PNG (BD) LTD. (NEW SHED)

Karerhat, Sattaroa, Jorarganj, Mirsharai, Chattogram
(22.9414841, 91.5560009)

17 August 2022

- 1. Store Shed:** Single-storied steel shed.

Store Shed

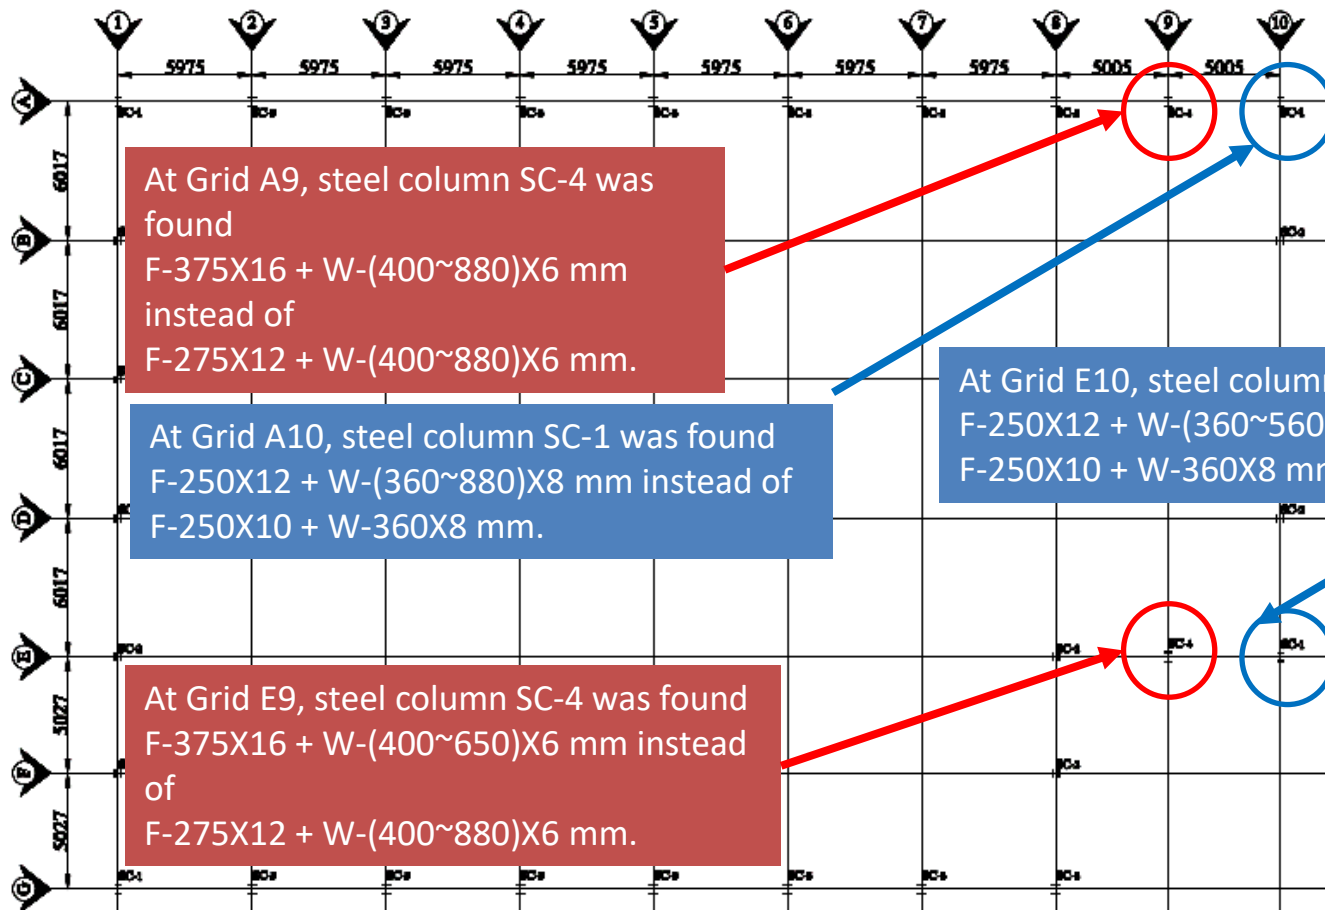
Design report not available

As per BNBC, every building or structure designed shall have its design documents prepared in accordance with the provision of Section 1.9.1. The design document shall include a design report, and a set of structural drawings, which shall be prepared in compliance with section 1.9.1.1 and section 1.9.1.2 as per BNBC.

At the time of inspection, the design report was not available which is required to be prepared in compliance with section 1.9.1.1 and section 1.9.1.2 of BNBC (part-6).
